FVS MIS-MATCH

(see DS00 FVSMisMatch.pdf)

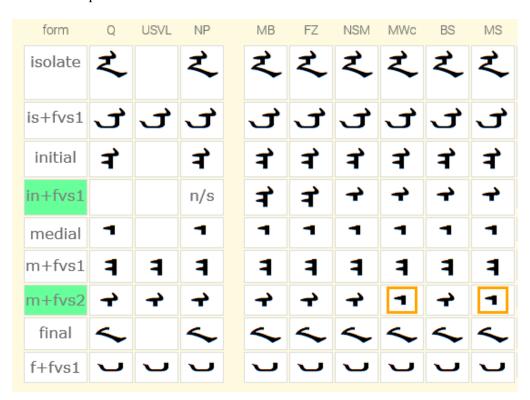
There are two opinions on how to determine the position of a glyph before/after the NNBSP/MVS. The first method as written up in the earliest documentation (MGWBM/TR170) seems to hold to the idea that anything between the first letter and the last letter of a Mongolian word is in the medial position. If there is a NNBSP or a MVS control character in the middle of the word, the letters adjacent to the NNBSP/MVS are still considered to be in the medial position. The second method as implemented by font developers (at least those in our forum) is to consider the letters pre/post NNBSP/MVS as final/initial. In other words, the letter before an NNBSP/MVS (assuming that the string of letters preceding the NNBSP/MVS has more than one letter) is considered to be in the final position. A letter following an NNBSP/MVS is considered to be in the initial position (assuming that the string of letters following the NNBSP/MVS has more than one letter). The Microsoft Universal Shaping Engine (aka Uniscribe) and the Google Harfbuzz rendering engine both follow the second method. This has created a "disconnect" between those holding to the first method and those holding to the second method. There are several cases where we can see that a font has placed the FVS assignment in two locations, thus following both methods rather than holding to one opinion.

Proposal: Leave the fonts as they are (in running text implementation). Glyph shaping in running text displays fine. It is the FVS specification where we find variation and duplication. Change the FVS specification to match the actual positions as determined by the font rendering engines. Given such a specification, the individual font developers will know how to change their FVS implementations in their individual fonts.

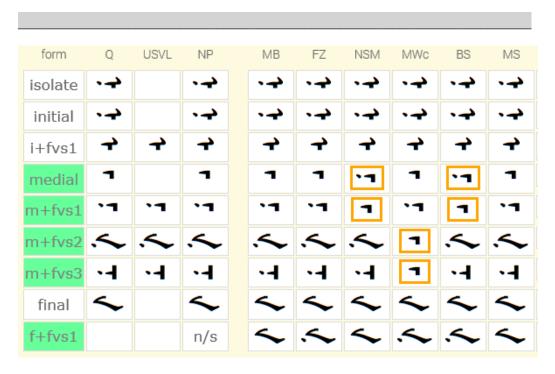
- U+1820-A (post-NNBSP) by the MGWBM, TR170, and current Chinese Standard: **Medial**ZWJ+1820+FVS2+ZWJ

* Third Medial Form
- U+1820-A (post-NNBSP) by the Universal Shaping Engine (Uniscribe) / Harfbuzz: **Initial**

- U+1828-N (pre-MVS) by the MGWBM, TR170, and current Chinese Standard: **Medial**ZWJ+1828+FVS2+ZWJ

Third Medial Form
- U+1828-N (pre-MVS) by the Universal Shaping Engine (Uniscribe) / Harfbuzz: Final

- U+182C-Q (pre-MVS) #1 by the Universal Shaping Engine (Uniscribe) / Harfbuzz: Final
- Proposed

- U+182C-Q (pre-MVS) #2 by the MGWBM, TR170, and current Chinese Standard: **Medial** ZWJ+182C+FVS3+ZWJ Fourth Medial Form
- U+182C-Q (pre-MVS) #2 by the Universal Shaping Engine (Uniscribe) / Harfbuzz: Final
- Proposed | ZWJ+182C | First Final Form

Proposed

Proposed

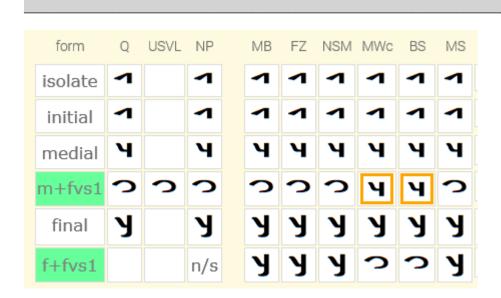
- U+182D-G (pre-MVS) by the Universal Shaping Engine (Uniscribe) / Harfbuzz: Final

• U+1835-J (pre-MVS) by the MGWBM, TR170, and current Chinese Standard: Medial

• U+1835-J (pre-MVS) by the Universal Shaping Engine (Uniscribe) / Harfbuzz: Final

- U+1836-Y (pre-MVS) by the MGWBM, TR170, and current Chinese Standard: Medial
 ZWJ+1836+FVS2+ZWJ
 Third Medial Form
- U+1836-Y (pre-MVS) by the Universal Shaping Engine (Uniscribe) / Harfbuzz: Final
